**Amendments To The Drawings:**

Application Serial No. 10/663/069  
Reply to Office Action of 09/18/2006

**Replacement Sheet of FIGS. 6 and 7  
(a total of 1 sheets of drawings)**

FIG. 6

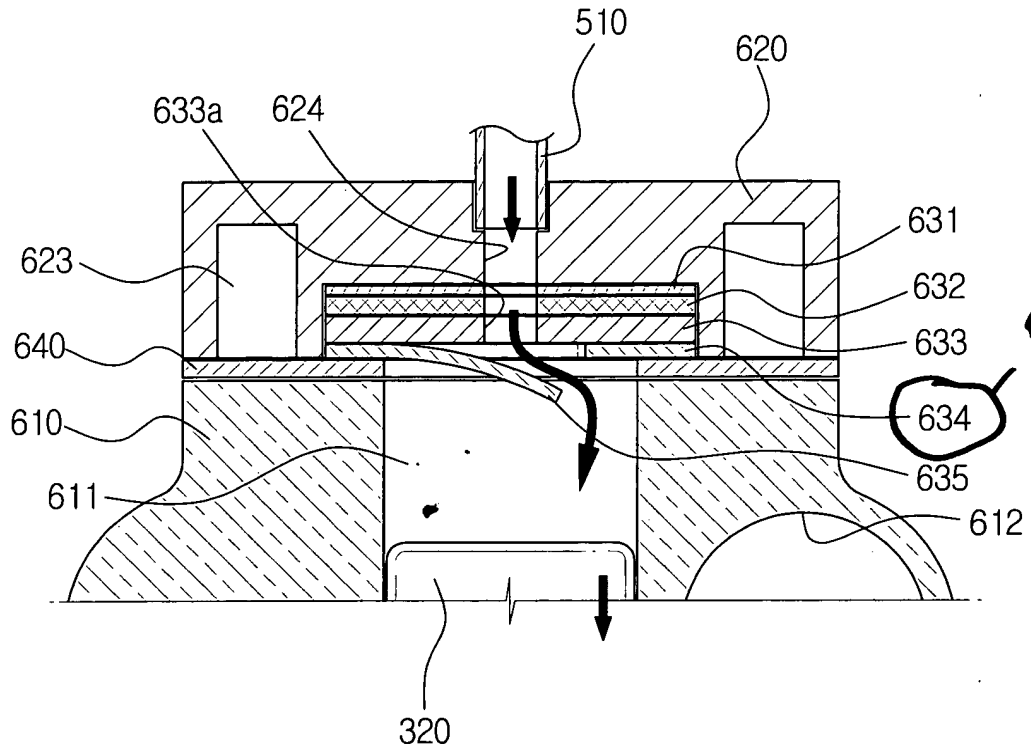
In the office action, the drawings were objected to because reference numeral 624 identifies two different structures in FIG. 6. In response to the drawing objection, the applicant is submitting an amended FIG. 6, which deletes one instance of reference numeral 624 and replaces it with reference numeral 634. The revision to FIG. 6 is encircled in red on the attached annotated sheet. The revision is hidden on the attached replacement sheet for FIG. 6 and 7.

The attached drawing sheets include one annotated sheet showing one change to FIG. 6. The other attached sheet is a replacement sheet in which the revision shown on the annotated sheet is hidden.
